UNITED STATES PATENT AND TRADEMARK OFFICE

APPLICATION NO.	FILING DATE	FIRST NAMED INVENTOR	ATTORNEY DOCKET NO.	CONFIRMATION NO.
10/728,117	12/04/2003	Rainer Dittrich	22733	7654

Office Action Summary

DETAILED ACTION

FIG. 4

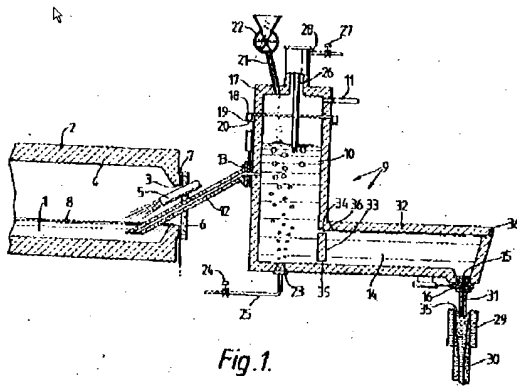
Claims 1 to 7 are rejected under 35 U.S.C. 103(a) as being unpatentable over Nashiwa et al (US 4,043, 798). Nashiwa et al discloses a process for producing steel using a projectile for introducing calcium into molten steel as shown in FIG.4

The projectile has a diameter of 5 to 100mm, preferably 25 to 50 mm which overlaps the claimed feeding pieces with a size 2 to 50 mm (col. 4, lines 23 to col.5, line 54) in view of which the crux of the process as claimed in Claim 1 is regarded as obvious. The
